ADDENDUM NO. 003 (Rev 01/2017)
ISSUE DATE: **04/06/2023**

RE: **WARF SMPH 4th, 5th, 7th FLOOR RENOVATION
UNIVERSITY OF WISCONSIN-MADISON
610 WALNUT STREET
MADISON, WISCONSIN**

UWSA Project No. **A-21-010**
UW- Madison Project No. **0039-2115**

Graphic Scale	AS SHOWN
PRJ. Number	UW: MSN 0039-2115
	UWSA: A-21-010
Set Type	BD
Date Issued	02/01/2023
Sheet Number	A204

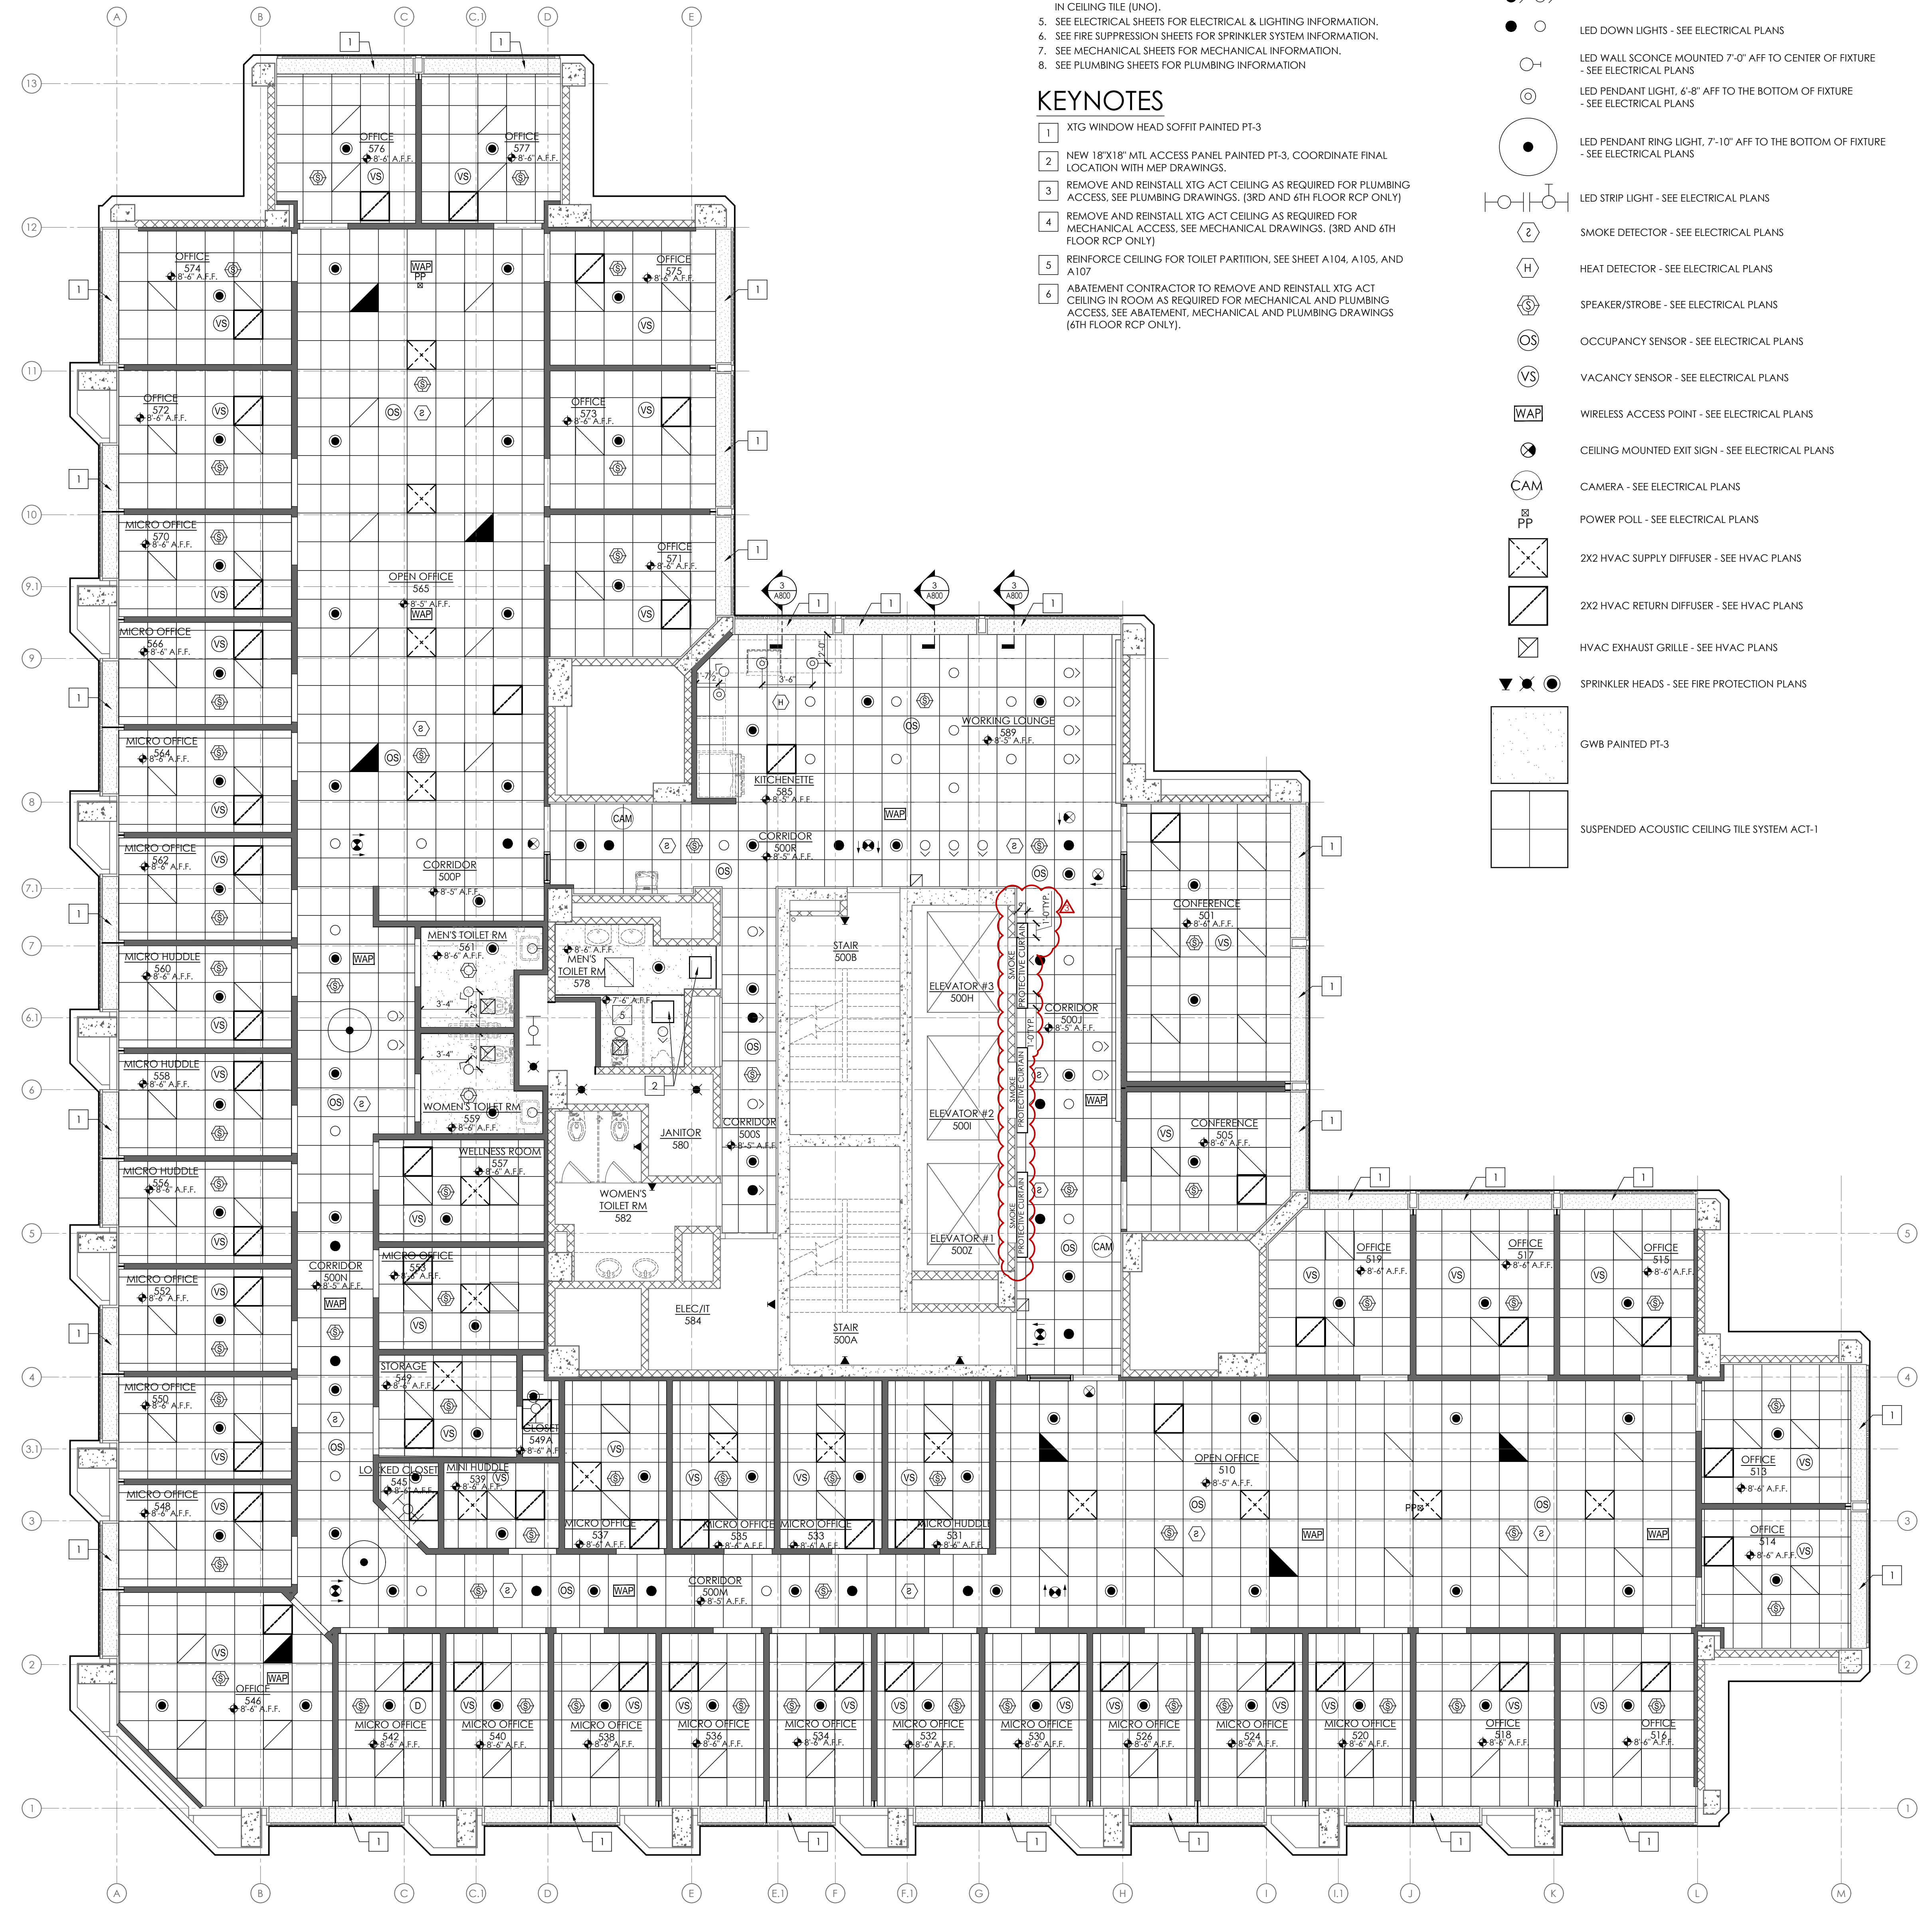
1. **ADD:** On sheet A204 coiling smoke doors have been added above each elevator door. See attached sheet A204.
2. **ADD:** On sheet A205 coiling smoke doors have been added above each elevator door. See attached sheet A205.

7TH FLOOR REFLECTED CEILING PLAN
3/16" = 1'-0"
0" 2" 4" 8" 12" 16"

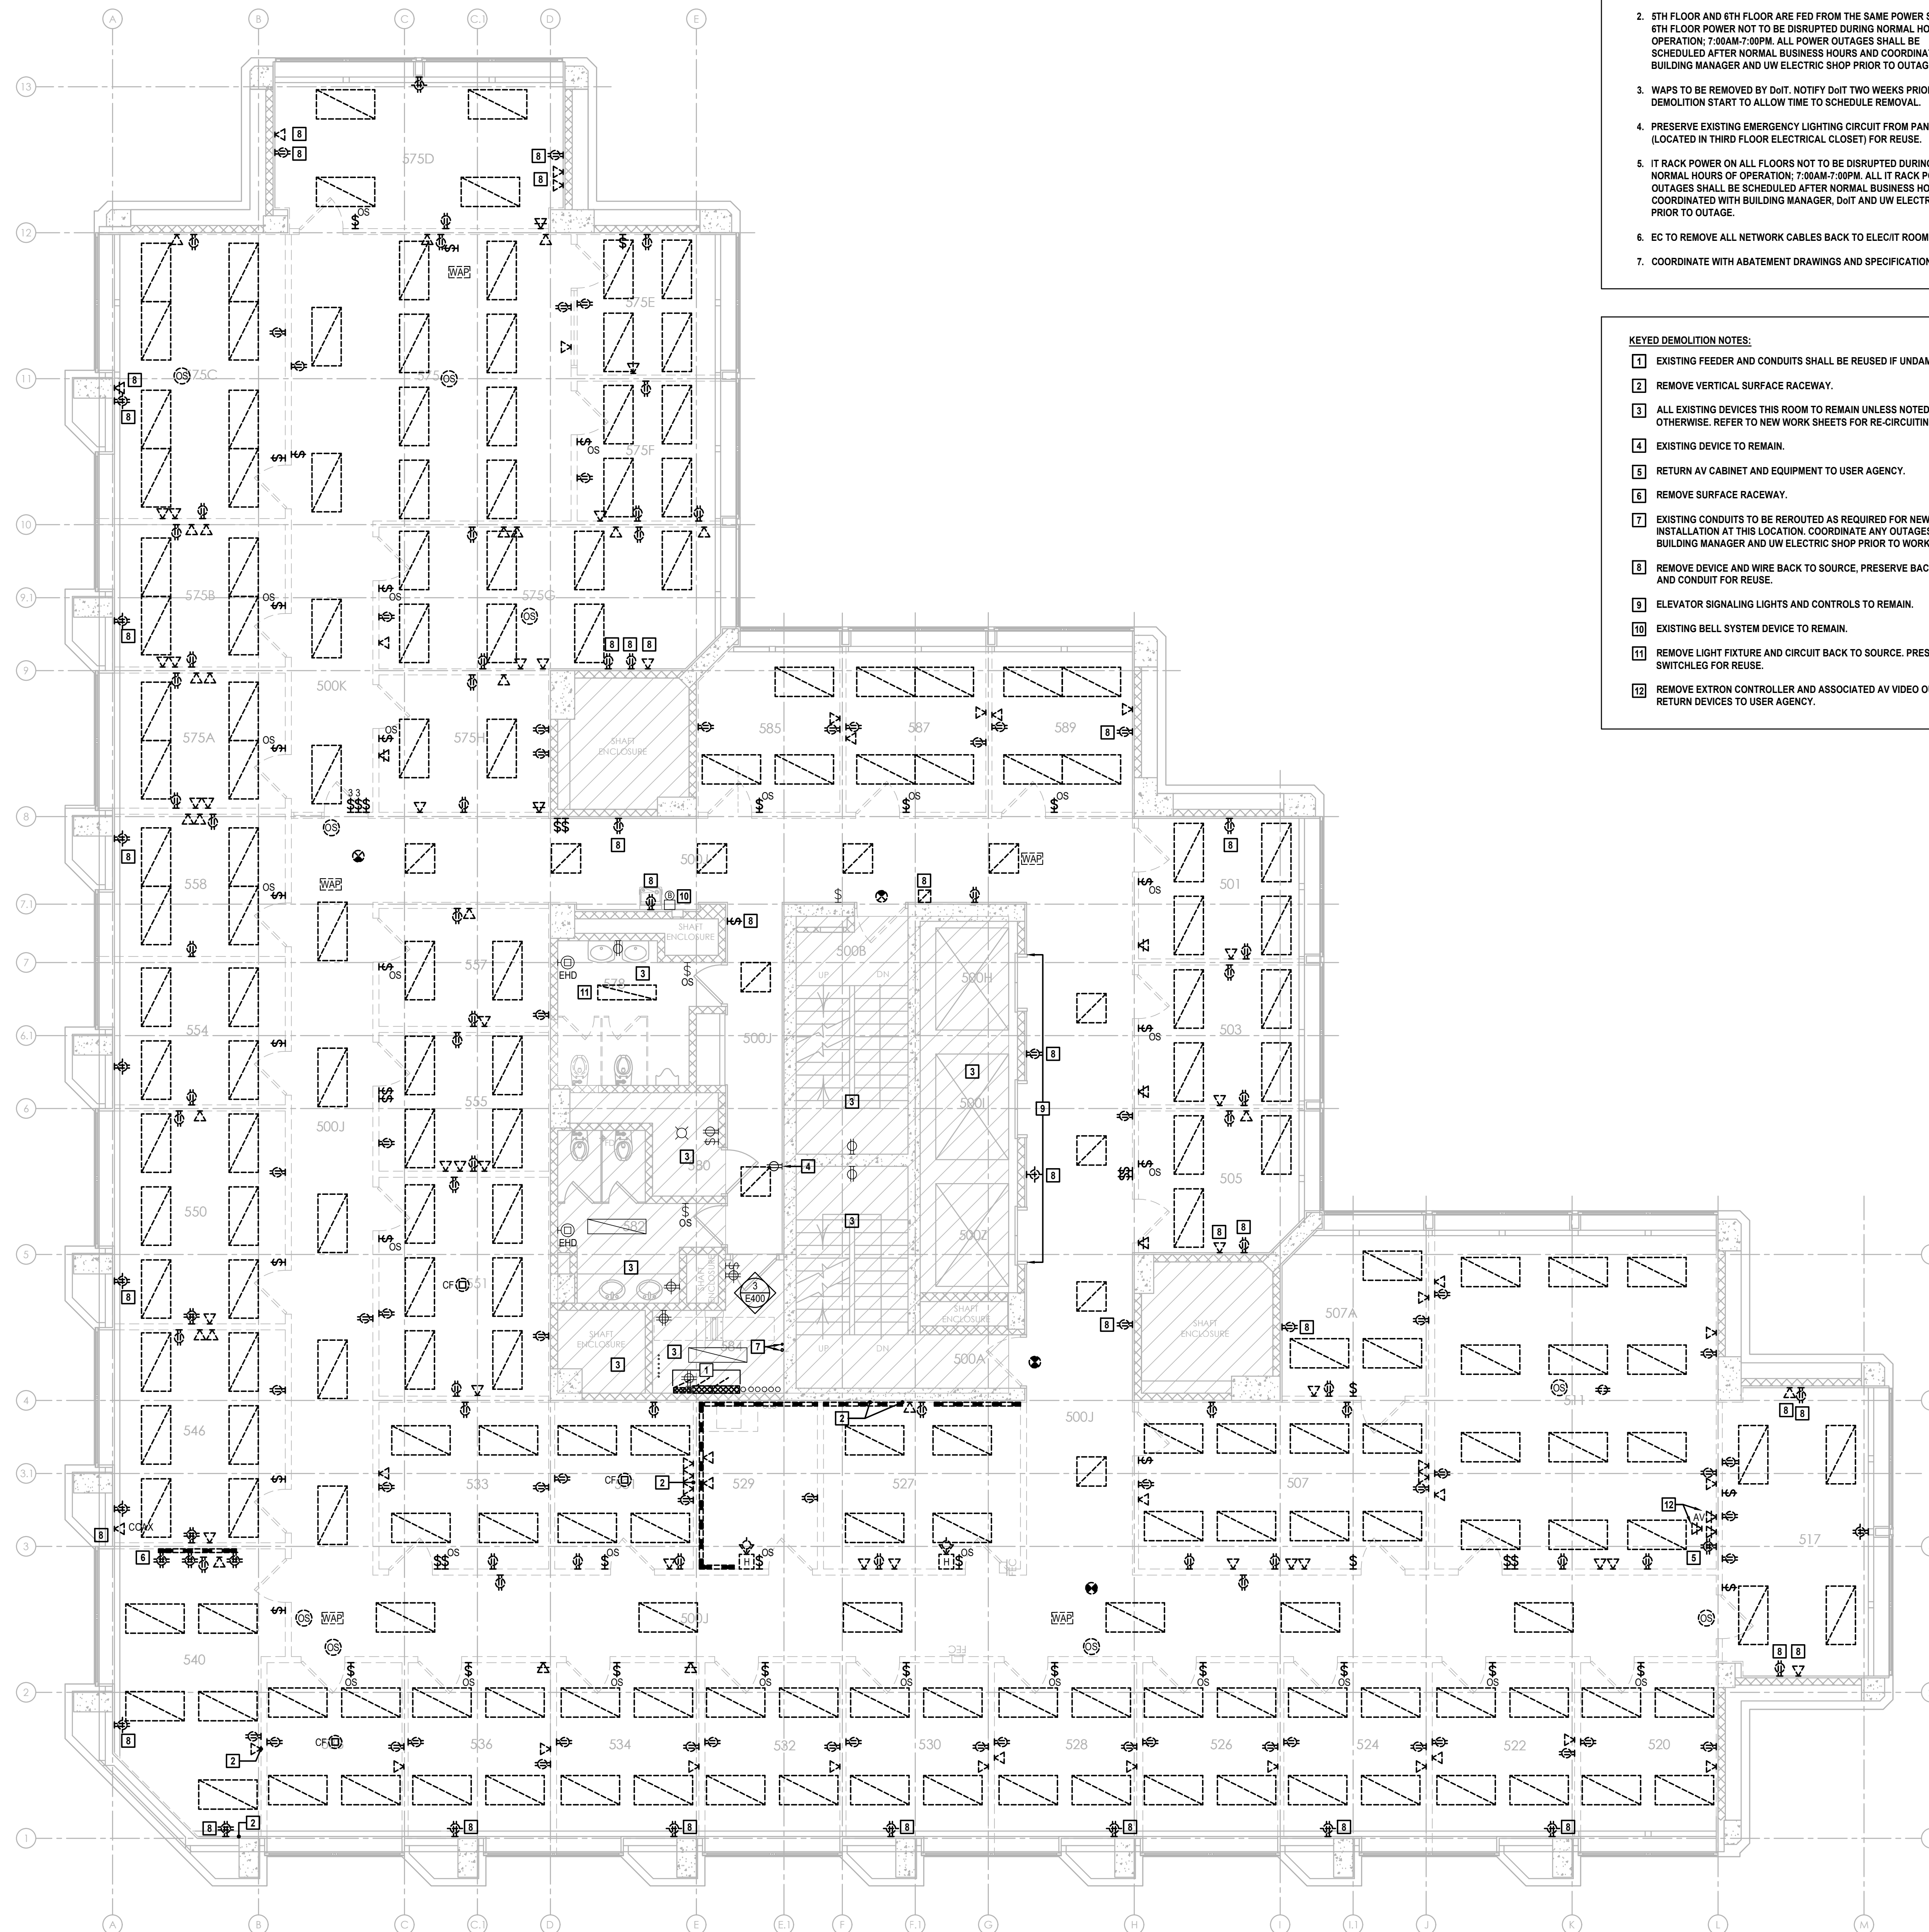
3. **ADD:** On sheet A207 coiling smoke doors have been added above each elevator door. See attached sheet A207.
4. **REPLACE:** Replace sheet PD107 in the Mechanical Section of the drawing set with missing sheet MD107.

Graphic Scale	AS SHOWN
PRJ. Number	UW: MSN 0039-2115 UWSA: A-21-010
Set Type	BD
Date Issued	02/01/2023
Sheet Number	MD107

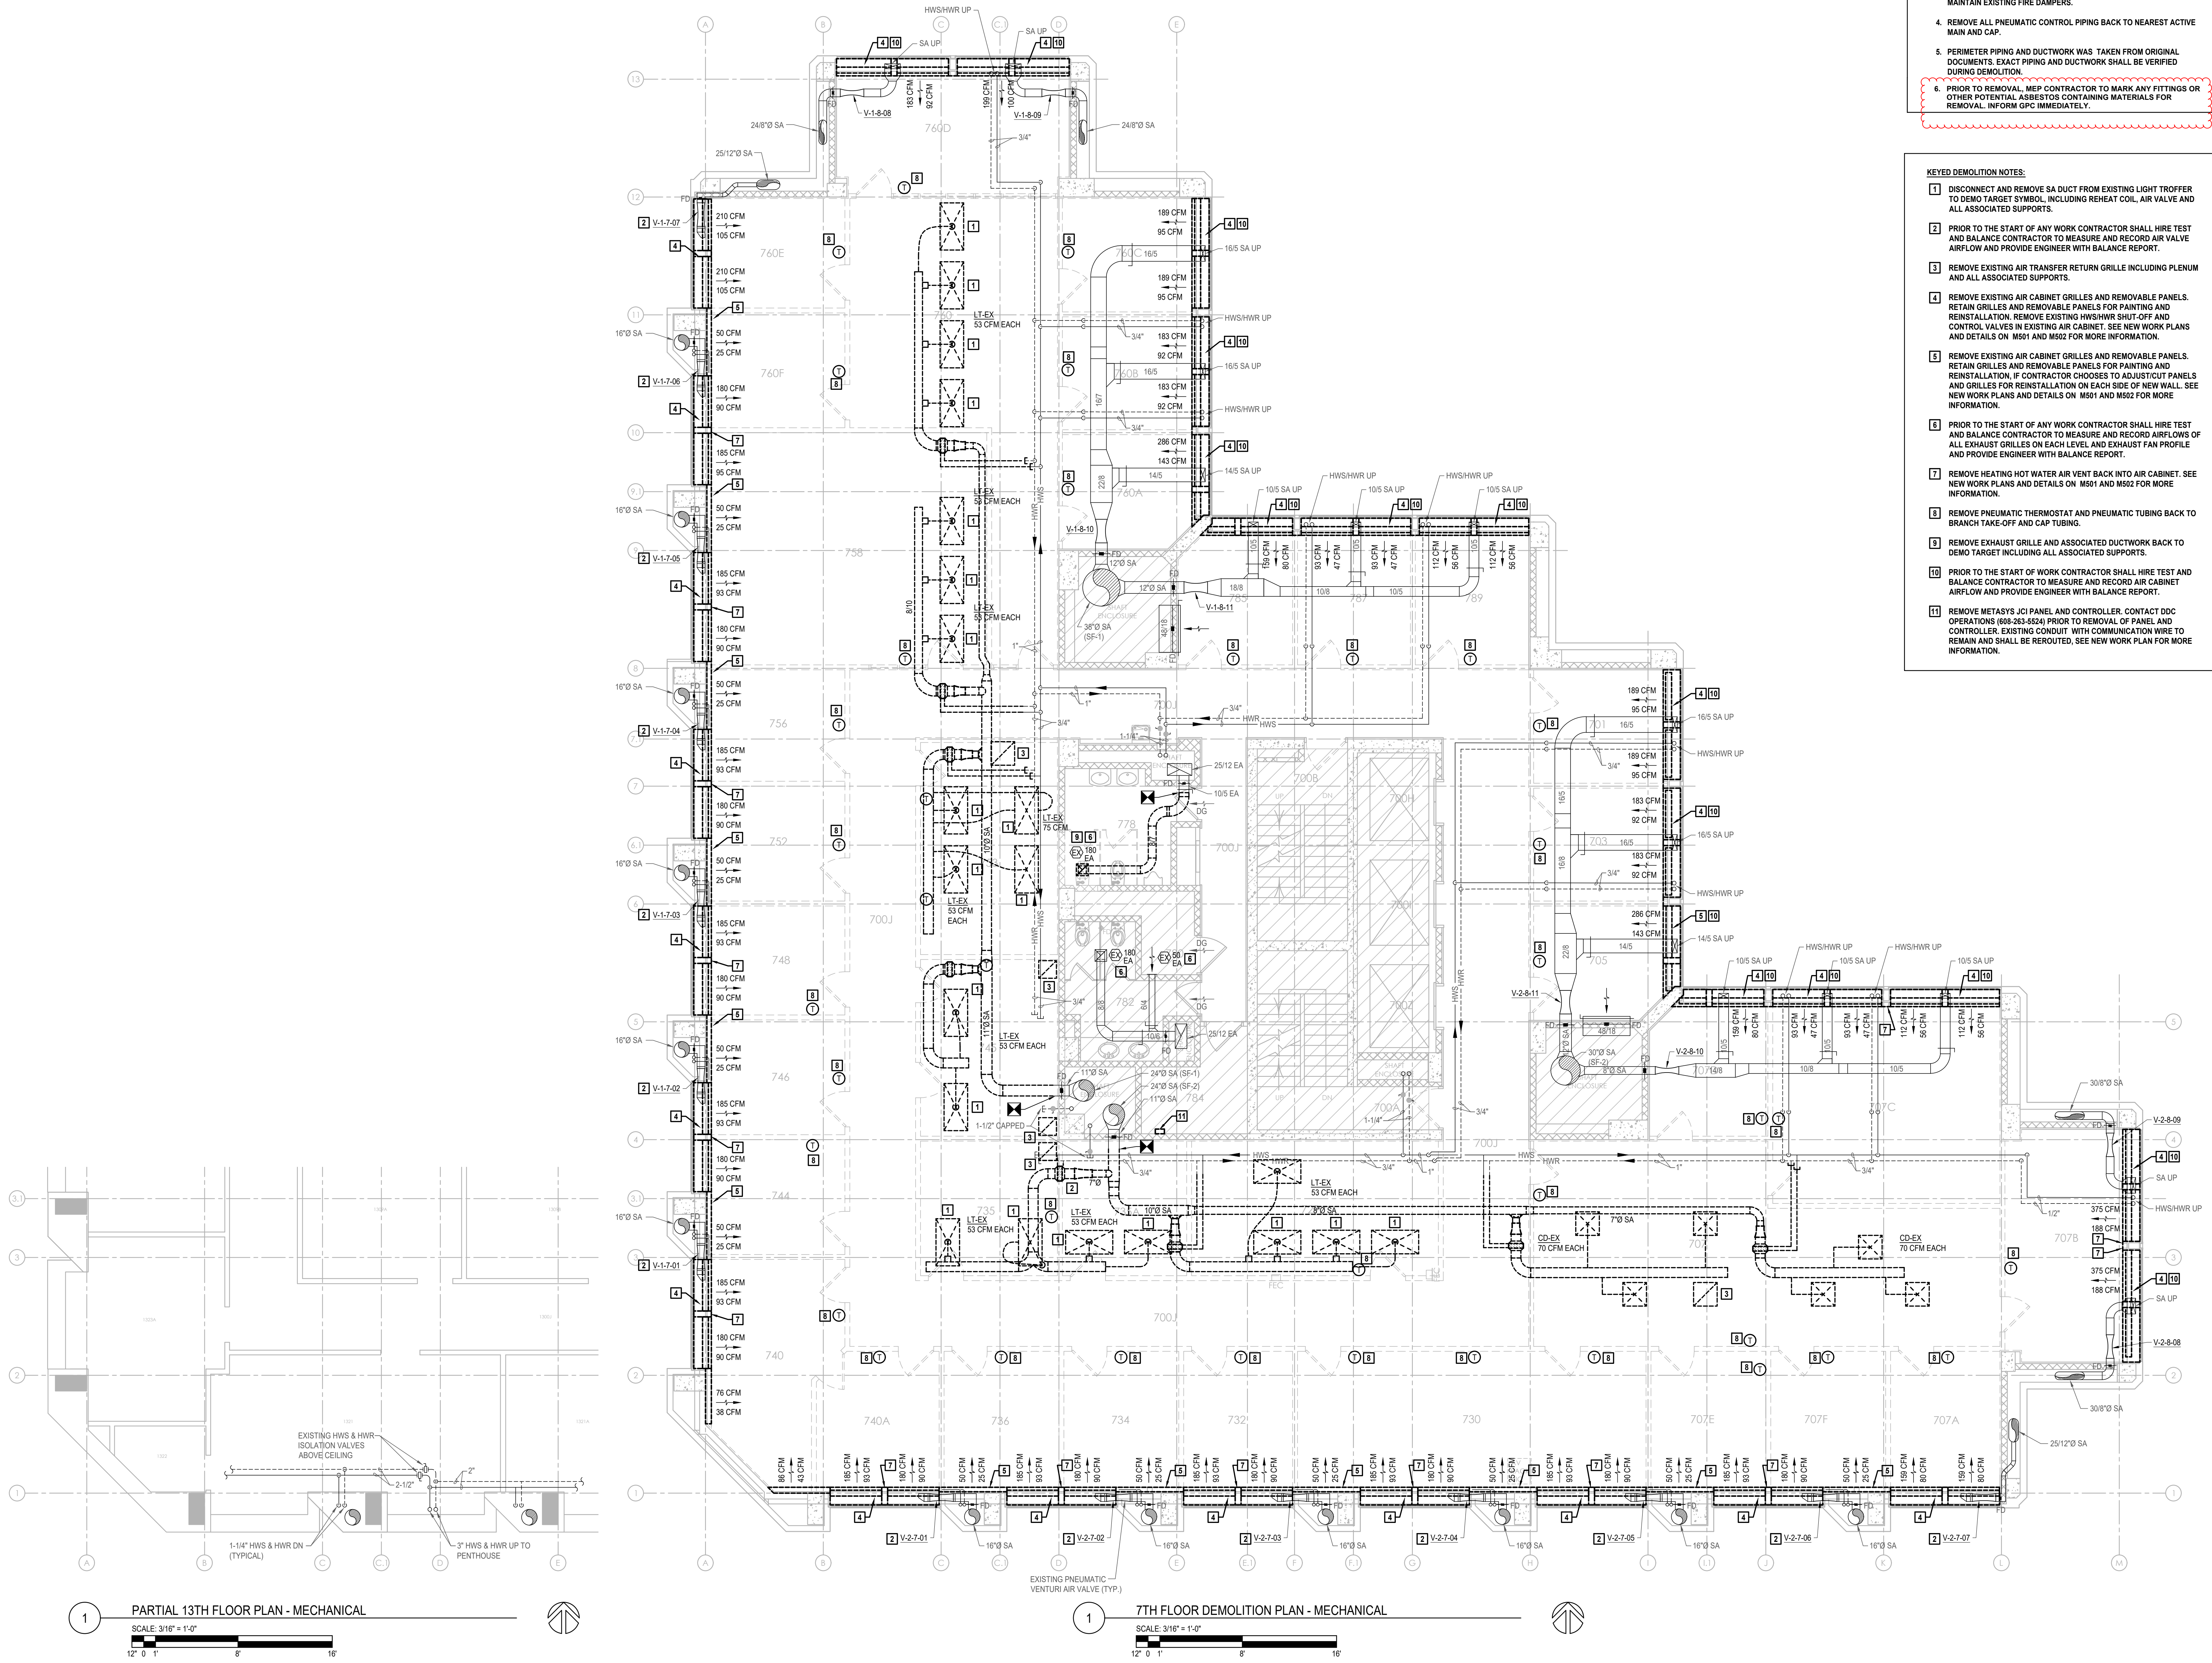
13. **ADD:** On sheet MD107 revise General Note 2 to read “PRIOR TO REMOVAL, MEP CONTRACTORS TO MARK ANY FITTINGS OR OTHER POTENTIAL ASBESTOS CONTAINING MATERIALS FOR REMOVAL. INFORM GPC IMMEDIATELY.”
